BUILDING PERMIT AND INSPECTION RECORD

Municipal #: **2026047141**
Process Number: M2026007470
Issue Date:

Application Type: ALTER INTERIOR
Proposed Use: RESTAURANT-CAFETERIA
Sq. Ft.: 900 / Units: 0 / Floors: 0
Permit Type: MUNICIPAL BLDG / Permit Category: 0001 MUNICIPAL GENERAL BUILDING

PROJECT LOCATION
PINECREST BAKERY
15519 NW 67TH AVENUE
MIAMI LAKES, FLORIDA 33014

SHEET NO.
A-1.0

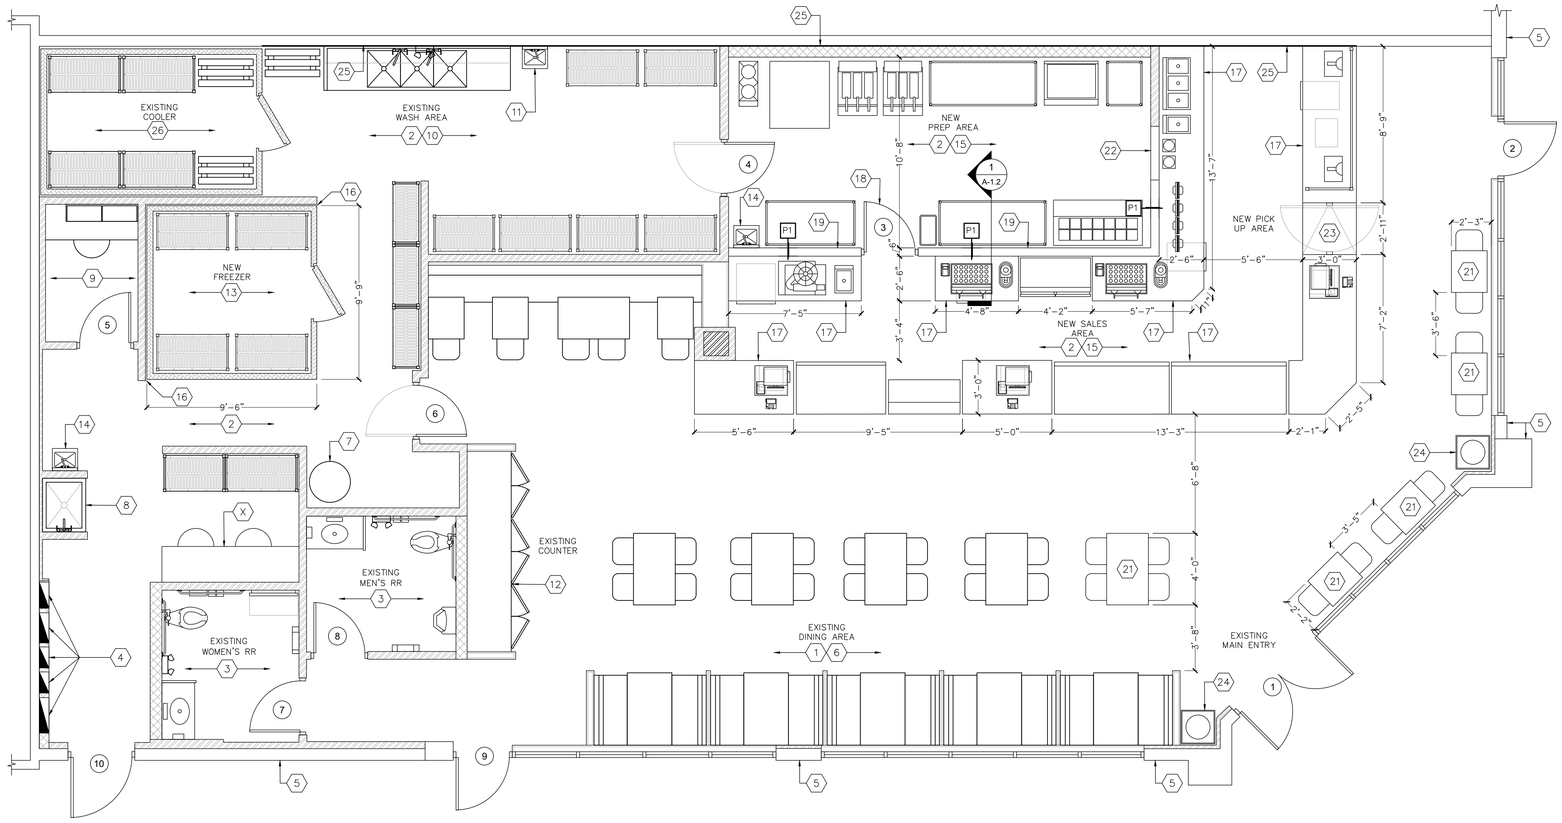
C. REWORK 03-14-26 Sheet A-1.0 indicates existing equipment will be removed. Floor plan must clearly show location and type of existing equipment. Response sheet indicates that previously approved fire stamped plans will be provided to documents existing approved kitchen hood installation although not provided. **Please see responses 15A and 15B below.**

REWORK 03-14-26 Sheet A-1.0 indicates existing equipment will be removed. Floor plan must clearly show location and type of existing equipment. Response sheet indicates that previously approved fire stamped plans will be provided to document existing approved kitchen hood installation although not provided.

SHEET NO.
E-2.0

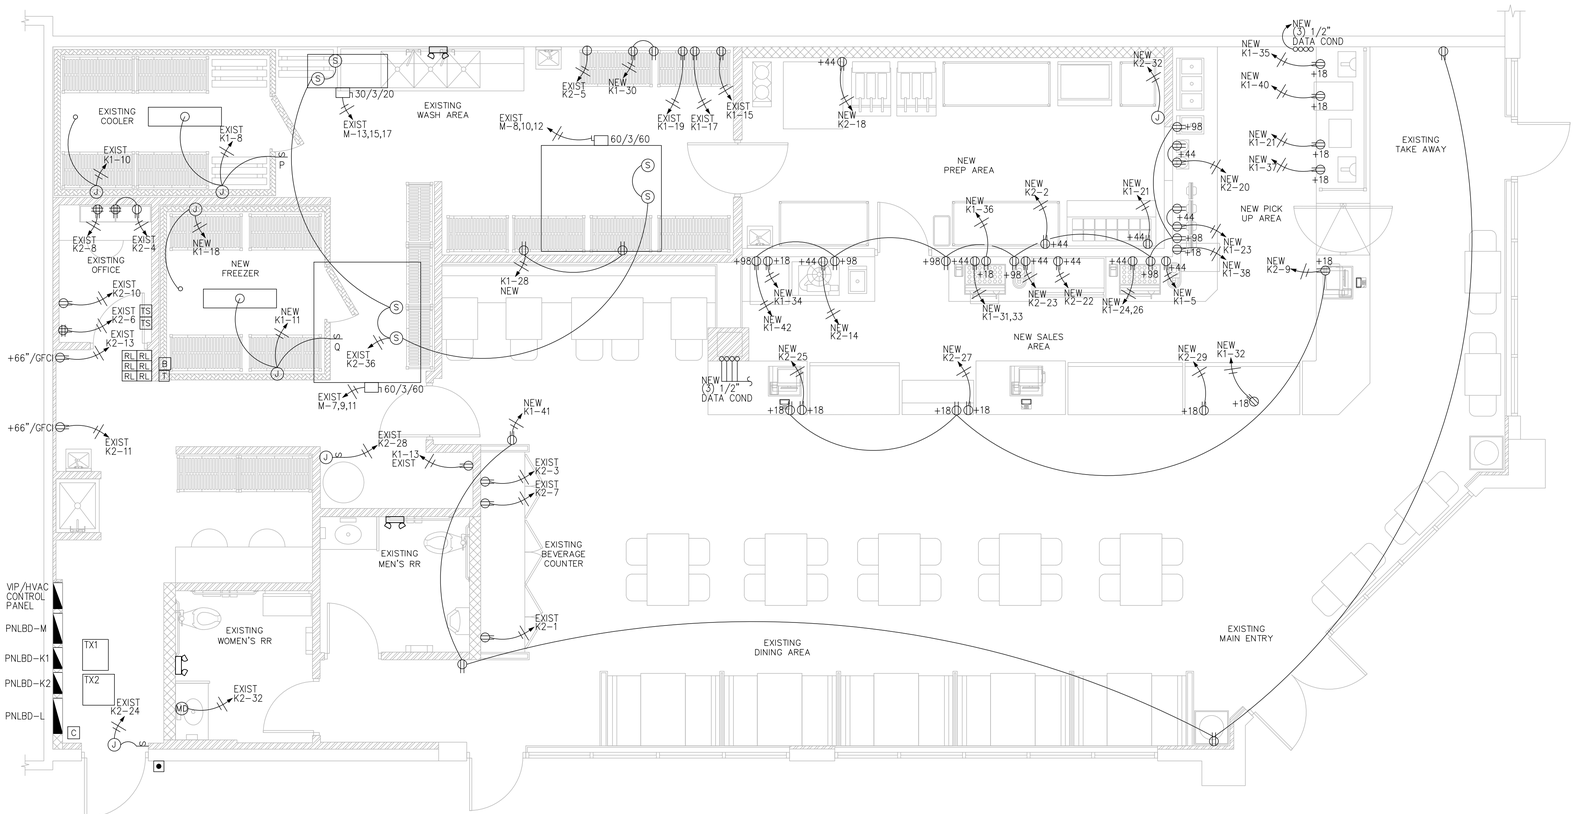
1. Show window receptacle outlets must be located within 18 inches of the top of a show window. NEC 210.62. **Please refer to SHEET E-2.0 for store front window receptacles.**

2. GFCI protection is required for all receptacle outlets in non-dwelling kitchens, regardless of location or use. NEC 210.8(B)(3). **Please refer to sheet E-2.0 for a note (GFCI protection must be installed for all receptacles) in each area where it is required.**

SHEET NO.
E-3.0

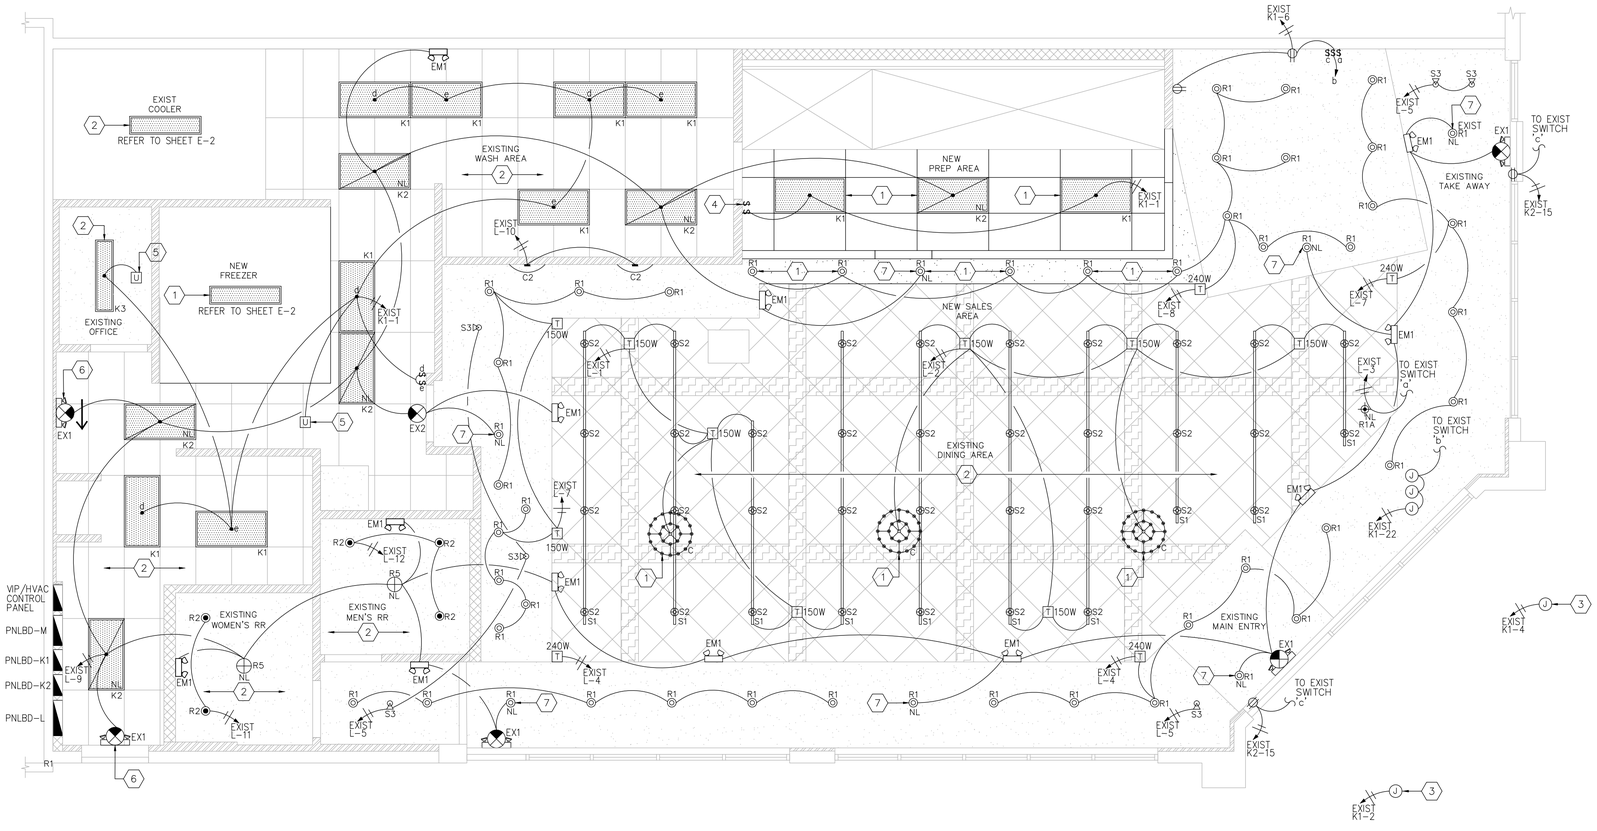
3. Please Provide Occupation sensor in restrooms per sections C405.2.1. **Please refer to sheet E-3.0 for occupation sensors in restrooms.**

SHEET NO.
LS-1.0

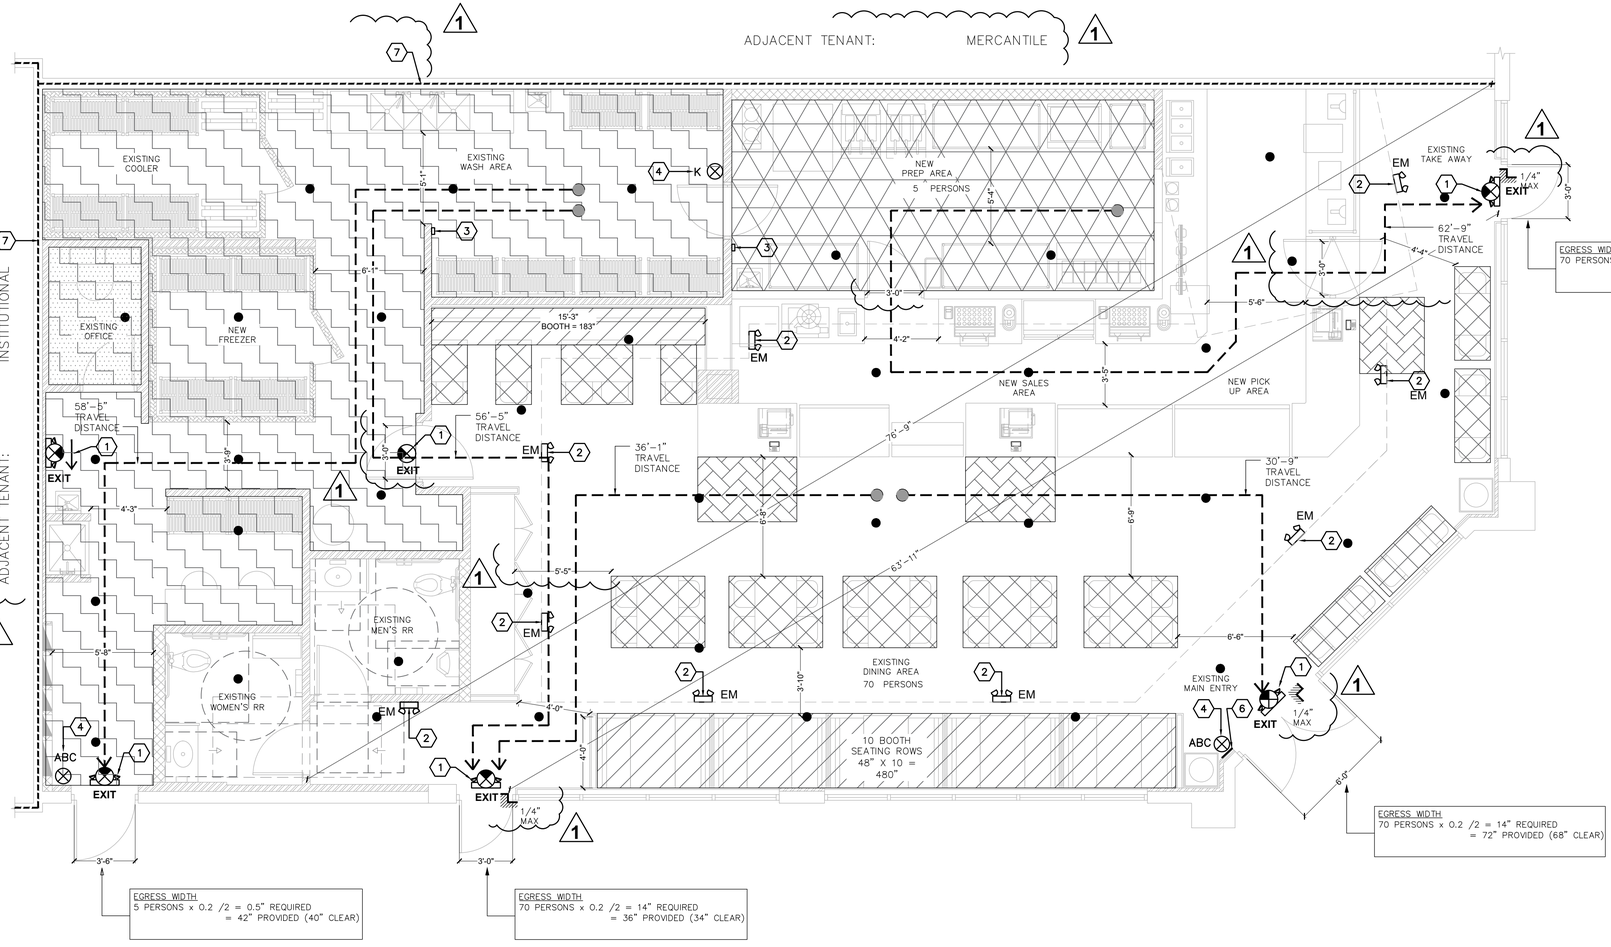
classifications. Call out fire rating in hours of walls separating occupancies on life safety floor plan. **Please refer to revised sheet LS-1.0. Adjacent occupancies and existing 2-hour fire rated walls are called out. Refer to keyed note #7 for assembly.**

10. FFPC101:7.1.6.2 Changes in Elevation. Abrupt changes in elevation of walking surfaces shall not exceed 1⁄4 in. Changes in elevation exceeding 1⁄4 in. but not exceeding 1⁄2 in. shall be beveled with a slope of 1 in 2. Show any changes in elevation on life safety floor plan. **Please refer to revised sheet LS-1.0. Chanes in elevation have been added and note added to general notes.**

11. FFPC101:7.2.1.3.1 The elevation of the floor surfaces on both sides of a door opening shall not vary by more than 1⁄2 in. Show changes in elevation at door opening do not exceed more than ½''. **Please refer to revised sheet LS-1.0. Chanes in elevation at door openings have been added.**

13. FFPC101: 7.2.1.4.3* Door Leaf Encroachment. 7.2.1.4.3.1 During its swing, any door leaf in a means of egress shall leave not less than one-half of the required width of an aisle, a corridor, a passageway, or a landing unobstructed, See kitchen exit access aisle next to walk in cooler door appears to be obstructing egress clear width clarify. **Please refer to revised sheet LS-1.0, egress by walk-in-cooler has been widened to be in compliance.**

14. FFPC101:7.7.1.2 New exit discharge paths to a public way shall have a width of not less than 36 in. Show means of egress from within are provided with a minimum 36" clear width to reach an exit this applies to all occupiable area. Show exit access path. Show throughout the floor plan for example exit door by pickup counter. Show clear width between tables and walkup counter is. **Please refer to revised sheet LS-1.0, added dimensions to doors and pickup counter door for egress width.**

SHEET NO. M-1.0

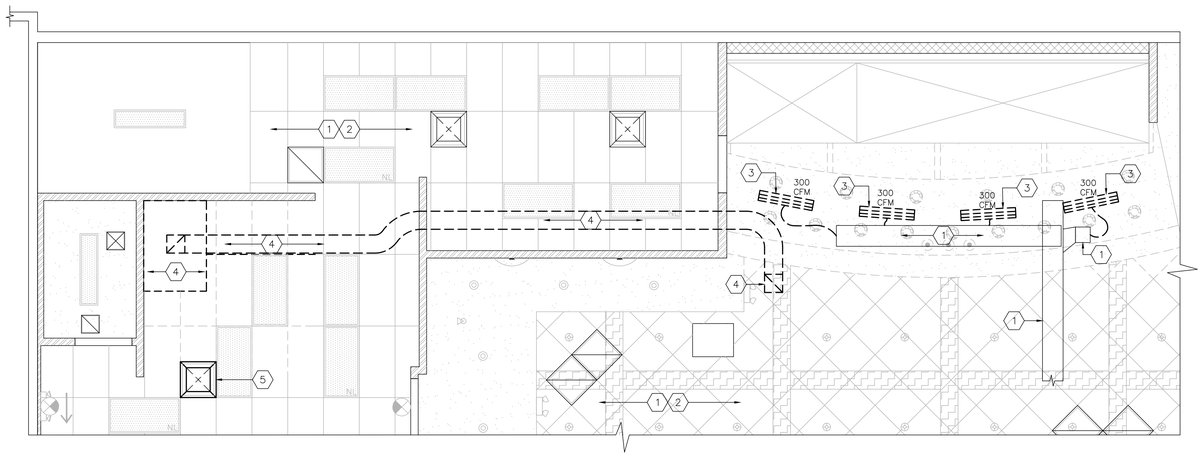
B. REWORK 02-24-26 Previously approved fire stamped plans may be provided if existing kitchen hood and equipment layout is to remain as previously approved. Sheet M-1.0 note number 3 indicates existing hood to be removed if modifications are proposed provide plans as required by NFPA 96. **Please see response 16C below.**

Sheet M-1.0 note number 3 indicates existing hood to be removed if modifications are proposed provide plans as required by NFPA 96.

SHEET NO. P-2.3

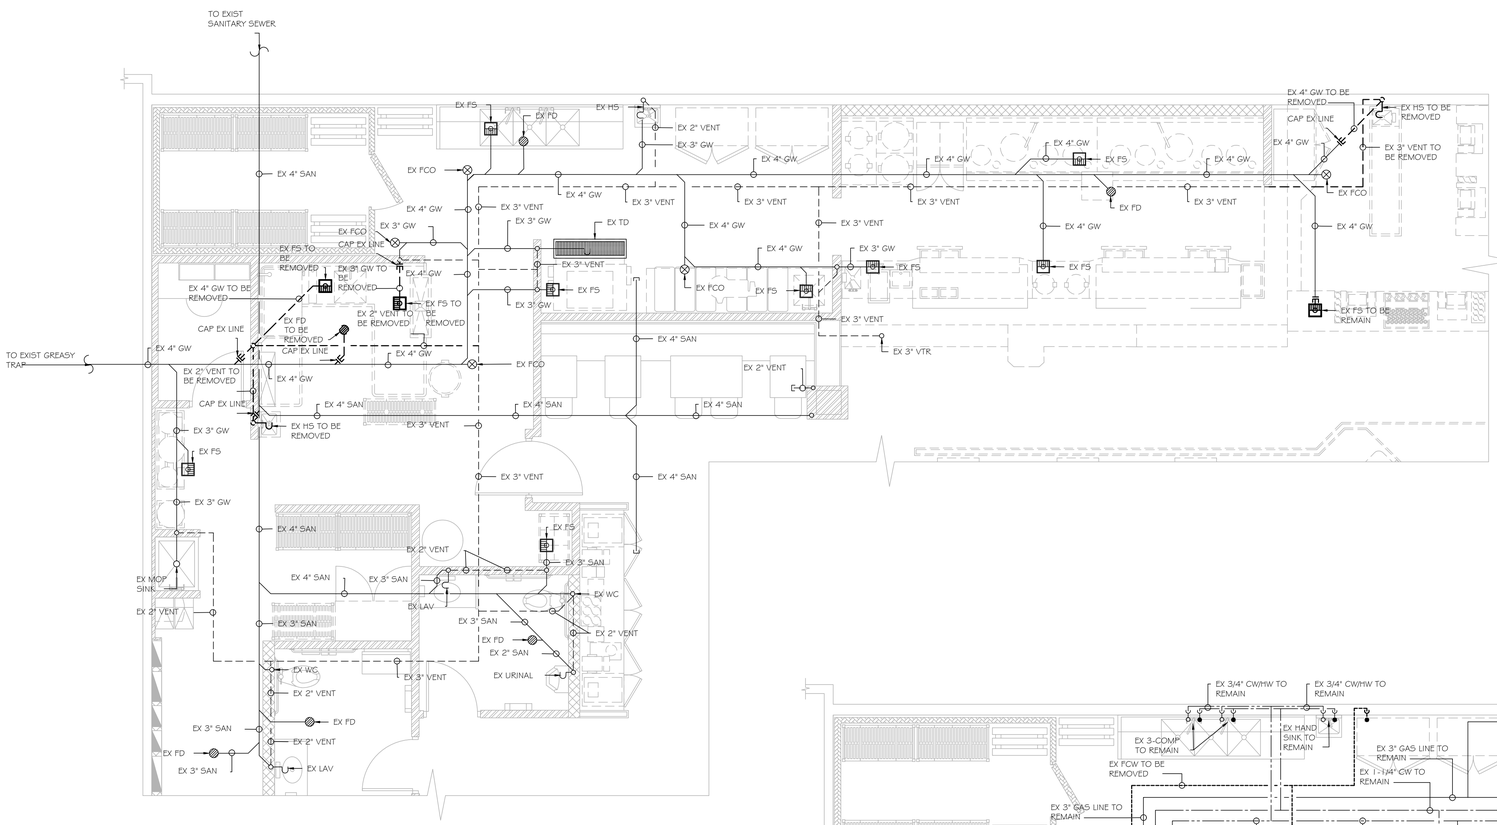
2. Revise peak flow calculation, when utilizing DFU to gpm conversion method the minimum flow allowed by code for a 4 inches line shall be 50 gpm. Revise calculation and POF. **Please refer to revised sheet P2.3 for new peak flow calculations.**

3. Revise plans in reference to the model of sampling port as two different one proposed. **Please refer to revised sheet P-2.3.**

5. In site plan (P-2.3) identify the North cardinal direction. **Please refer to site plan (P-2.3) for north cardinal direction**

1. Still showing 750 gal each at SIDE ELEVATION-CROSS SECTION VIEW on P-2.3. Please revise accordingly to C.A.R. **Please refer to the revised sheets P-2.3, grease trap gallon notes have been corrected.**

3. Plans must be revised for capacity in correspondence with Condition Assessment information. Revise all the sheets. **Please see revised sheet P-2.3 for corrected calculations and changes to grease trap gallon capacities.**

SHEET NO. P-1.0

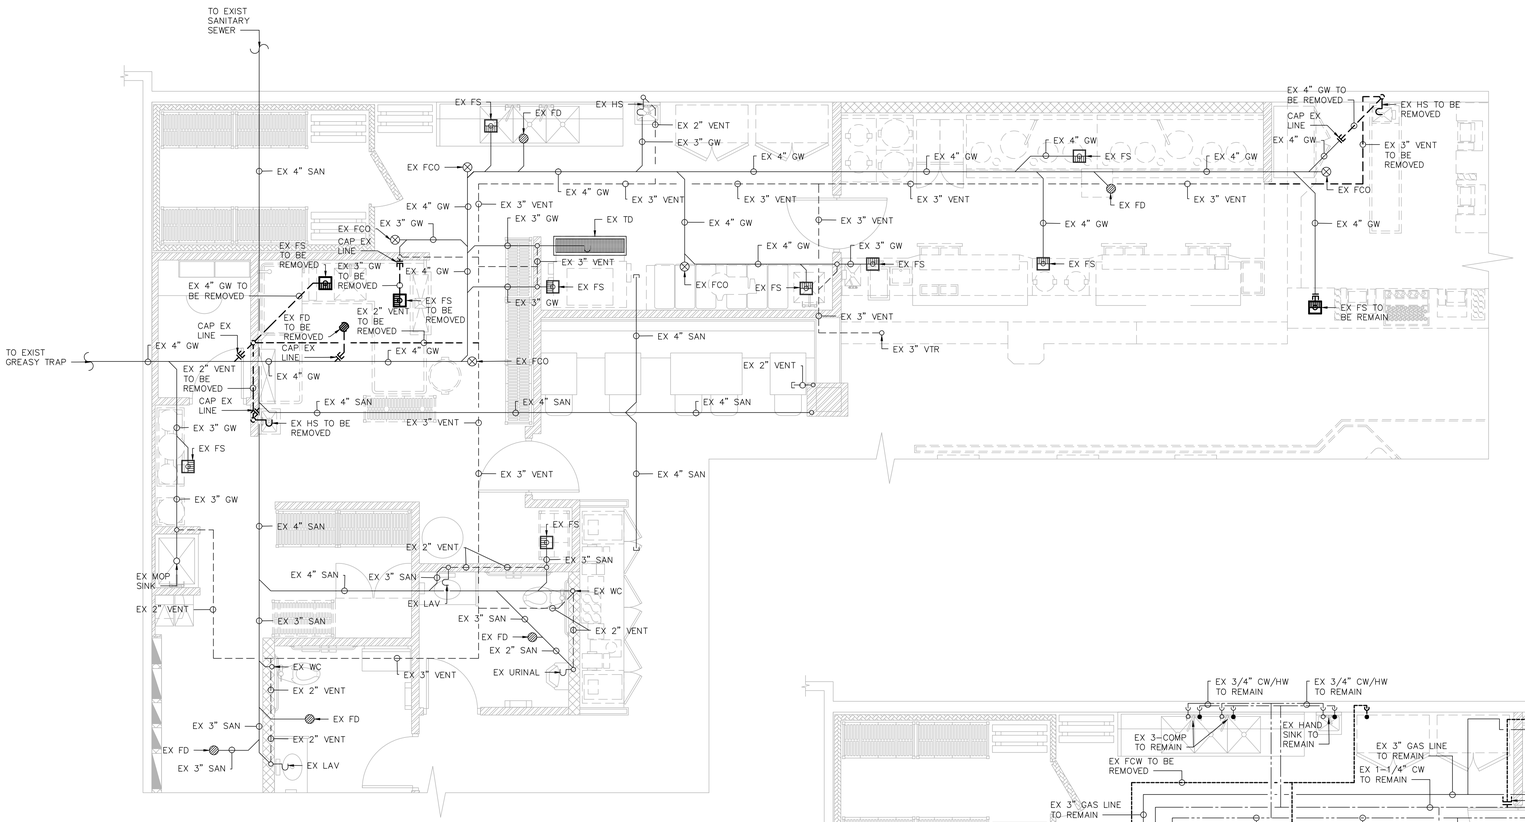
2. Please include the dimensions for sampling port model at system summary block on P-1.0 to read = { NEW DOUBLE TEE 6"x6"x4"x4". **Please see revised sheet P-1.0 for the note: New double tee 6"x6"x4"x4"**
